Metro 31

City of El Paso — City Plan Commission — 4/4/2019 SUSC18-00012 — Resubdivision Combination

SUMMARY OF REQUEST: The applicant proposes to resubdivide 11.67 acres of land into 5 mixed use lots as part of a SmartCode development. This application is being reviewed under Title 21 (SmartCode) and is required to comply with the approved Metro 31 Regulating Plan. The purpose of the replat is to divide lots to accommodate an apartment complex, SunMetro transfer center, and three streets (Jitney Lane, Metro 31 Avenue, and Gallivant Place). Access to the subdivision will be provided via Diana and Wren.

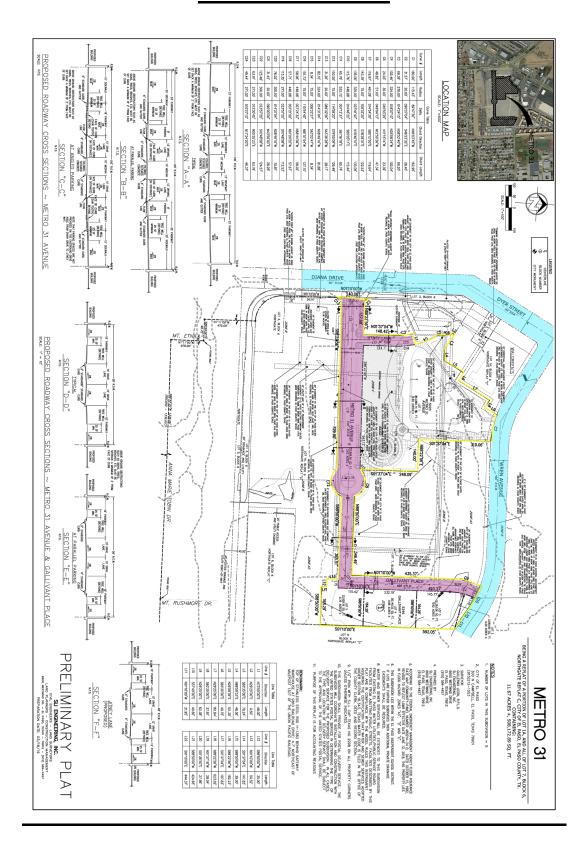
- 1. Please verify addresses. For lots on the north side of Metro 31 Avenue should be odd numbers.
- 2. Label the owner in note two on the preliminary plat.

- 3. Clarify the purpose of the replat.
- 4. Label cross-sections to match the Regulating Plan.
- 5. Submit to the Planning & Inspections Department Planning Division the following prior to recording of the subdivision:

- 1. On March 29, 2019, the Consolidated Review Committee approved a Preliminary Building Scale Plan (PLBS19-00002) and Regulating Plan Adjustment (PLRP19-00002) for the proposed development.
- 2. Please add the thoroughfare assembly nomenclature used in the Metro 31 SmartCode Regulating Plan (eg., "GALLIVANT PLACE (ST 58-38)") to the preliminary plat.

1. Show existing retention private pond on the Preliminary Plat and clarify if it is permanent or temporary.

- 1. Please provide correct cross-sections for Metro 31 Avenue and Gallivant Place.
- 2. Please ensure that proposed cross-sections are labeled to match the approved Metro 31 Regulating Plan.
